**SUBMISSION OF APPLICATION FOR PERMISSION UNDER SECTION 16 OF
THE TOWN PLANNING ORDINANCE (CAP. 131) FOR PROPOSED EXHIBITION HALL
AND SHOP AND SERVICES IN “OTHER SPECIFIED USES” ANNOTATED “PIER” ZONE,
PREMISES AT UPPER DECK, HUNG HOM (NORTH) FERRY PIER, HUNG HOM**

Planning Application No. A/K9/287

Further Information (1) – Technical Clarifications

Title	Elevations (South & North)	Legend	Drawn By	EC	Figure No.	F11-1
			Date	May 2024	Scale	1:300 in A4

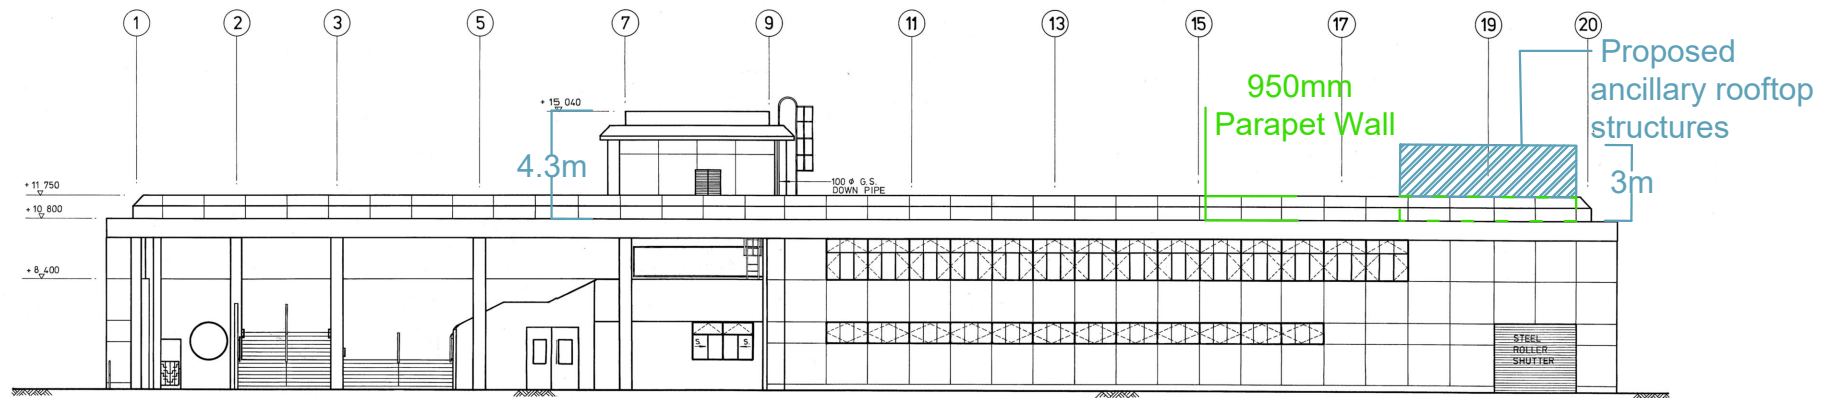
2. *Visual impact of the additional water tanks and pumps*

Please refer to the illustrations in Figure FI1-1 & FI1-2. It is demonstrated that the proposed ancillary rooftop structures with a height of not exceeding 3 metres in compliance with JPN no. 5, are lower than the existing plant room with a floor-to-floor height of 4.3m. Also, about one third of the massing of the proposed ancillary rooftop structures will be visually hidden behind the existing parapet wall enclosing the pier roof. Along with the photomontages submitted in Figure 10 of the formal submission, it is justified that the visual impact of the proposed ancillary rooftop structures is not higher than that of the existing plant rooms at the roof.
